## HISTORIC AND DESIGN REVIEW COMMISSION

March 21, 2018

**HDRC CASE NO:** 2018-111  
**ADDRESS:** 407 DEVINE ST  
**LEGAL DESCRIPTION:** NCB 2957 BLK 1 LOT 2 W 10 FT OF 3  
**ZONING:** R-5, H  
**CITY COUNCIL DIST.:** 1  
**DISTRICT:** Lavaca Historic District  
**APPLICANT:** Adriene Wilson  
**OWNER:** Adriene Wilson  
**TYPE OF WORK:** Replace existing carport with similar materials and same dimensions  
**APPLICATION RECEIVED:** February 16, 2018  
**60-DAY REVIEW:** April 17, 2018  
**REQUEST:**

The applicant is requesting a Certificate of Appropriateness for approval to construct a carport at the rear of the lot.

# Ranch

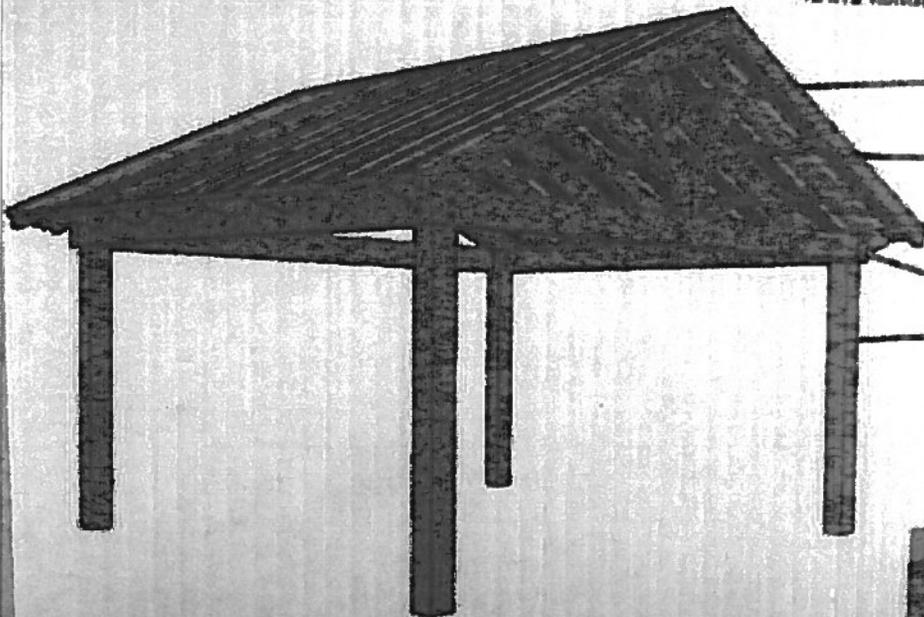
on the architectural style of the primary building and historic patterns within the district or be in the same location with a similar scale, proportion, color, and materials to the existing structure. Staff finds that the proposed location and wood framing consistent with the Guidelines. Staff finds that a standing seam metal roof or a v crimp roof would be more appropriate than corrugated metal.

Staff recommends approval to install a new rear carport based on findings b and c with the stipulation that the proposed roof feature standing seam metal with seams that are 1 to 2 inches in height, panels that are 18 to 21 inches in width, a crimped ridge seam and a standard galvalume finish or a v crimp roof.
